CONSULTANTS: [Blank space for consultant names]		ARCHITECT/ENGINEERS: H+L SOM CRA SAM ARCHITECTS / ENGINEERS 1144 Ardmore 1700 Mile Street Suite 100 Denver, CO 80202		Project Title CONCOURSE ENLARGED SERVICE LEVEL POWER PLANS Approved: Project Director		Project Title REPLACEMENT MEDICAL CENTER FACILITY, EASTERN COLORADO HEALTH CARE SYSTEM LOCATION AURORA, COLORADO Date 08/31/2012		Project Number 554-501 Building Number [Blank]		Drawing Number 01.ES.410.1		OFFICE OF CONSTRUCTION AND FACILITIES MANAGEMENT Department of Veterans Affairs	
---	--	--	--	--	--	---	--	--	--	--------------------------------------	--	--	--

3 01-01-E3 ENLARGED ELECTRICAL ROOM
 3/4" = 1'-0"

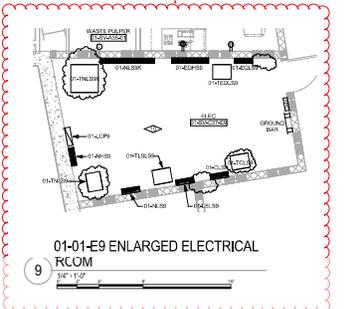
Please review KT RFI #20297 VA RFI #2685 for revised detail of Elec 01-01-E3-EN

In the RFI detail the following electrical equipment was to be added:
 1. 120V receptacle (240V receptacle removed) in 01-01-E3
 2. 120V SP receptacle in room 01-01-CL5-E2
